**REZONING,
PLANNED UNIT DEVELOPMENT
& SUBDIVISION STAFF REPORT**

Date: March 20, 2008

DEVELOPMENT NAME Graf Dairy Subdivision

Case # SUB2008-00040 ZON2008-00387
ZON2008-00388 ZON2008-00390

SITE PLAN

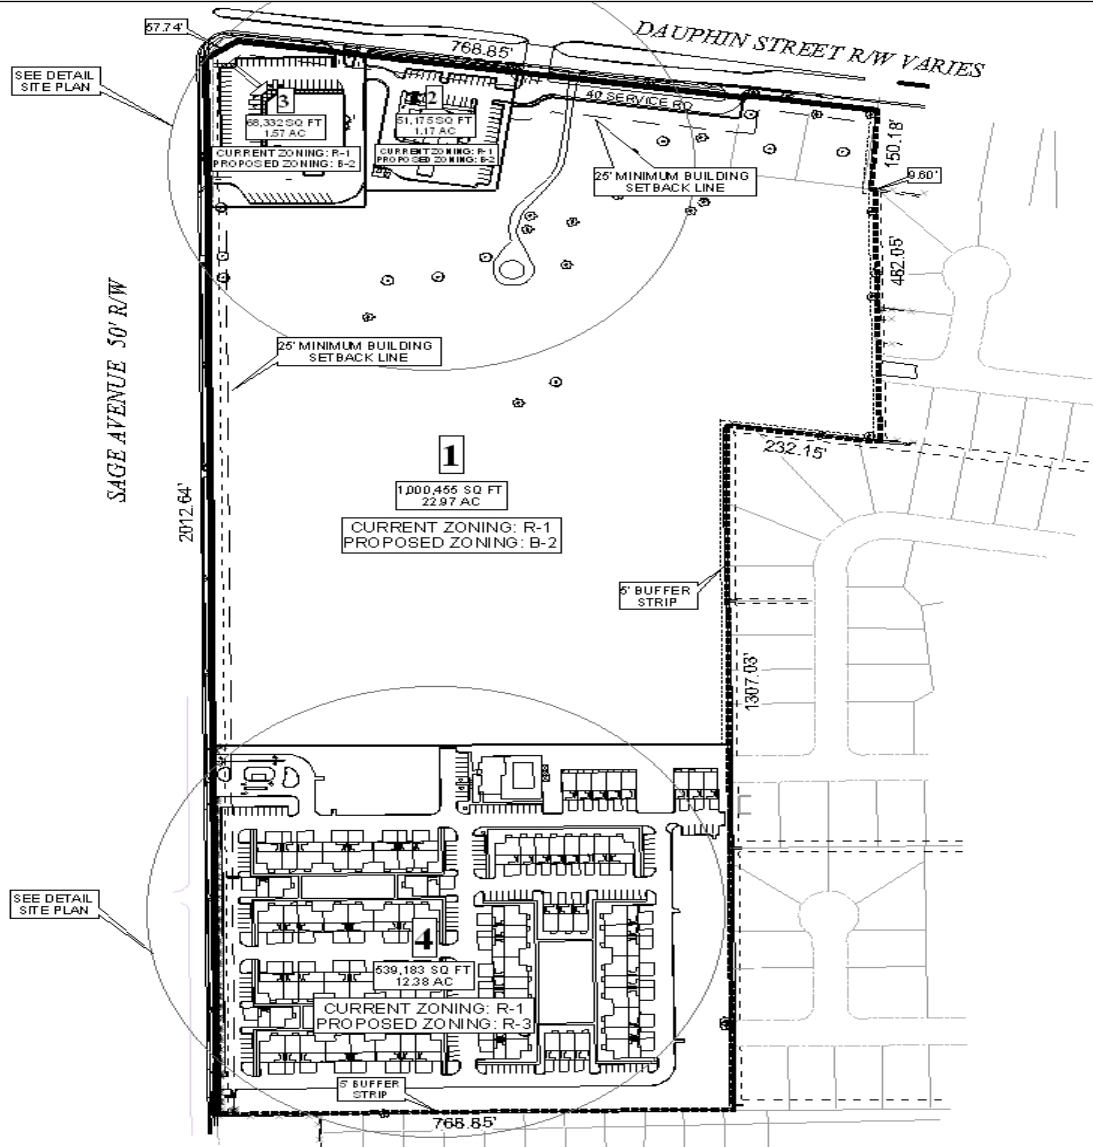
The plans submitted do not reflect dedications necessary to accommodate the findings of the Traffic Impact study. These dedications will necessitate adjustments to all site plans as submitted.

There is no indication on the site plan (with the exception of Lots 2 and 4) as to the proposed location of any dumpster or other waste storage facility. If the applicant utilizes a dumpster, the

A sidewalk along Dauphin Street will be required as part of the development, if approved, as will any necessary repairs to the sidewalk along Sage Avenue (or construction of new if dedication and/or roadway improvements are required). The site plan should be revised to show both sidewalks.

The plan illustrates a buffer strip (ranging from 5' to 10') along the South and East property lines, where the site abuts residential properties.

There are notes on the plans submitted that appear to relate to the previous applications and are in direct conflict with the site plans as submitted. Further, the notes address issues that should be illustrated on the plan and not addressed via a note.

The plans do not include any information regarding building height or window walls for the condominium development. This information is vital in that it specifically relates to building spacing requirements.
